PRODUCT CHANGE NOTICE

Dear Valued Customer,
This PCN C647 notice is to inform you of an upcoming design change regarding the enclosure fastening method used on selected GEN3 Electronic Battery Disconnect Switches.

PCN C0647

Gen3 EBDS Fastening Solution
Harmonization Using Self-Threading Screws

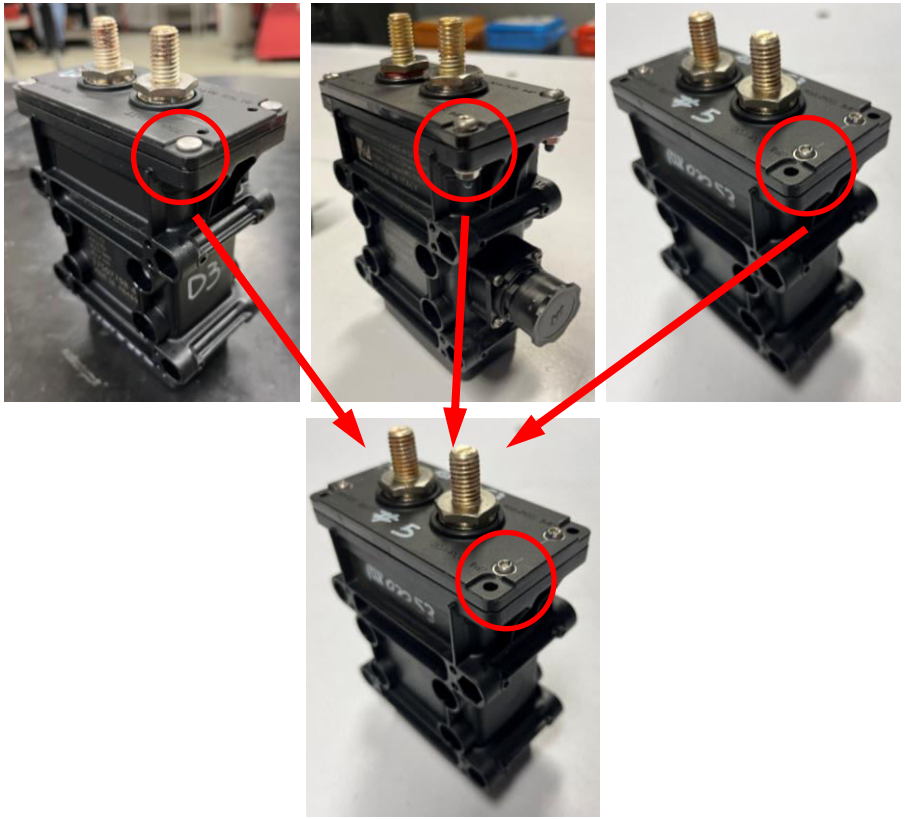
The Gen3 EBDS is closed so far by means of 3 alternative systems: 4 rivets, 4 bolts (screw + nut) or 4 self-threading screws.

As part of an ongoing harmonization effort, all variants will be standardized to a **4 self-threading screw configuration**, with the screws threaded directly into the plastic housing.
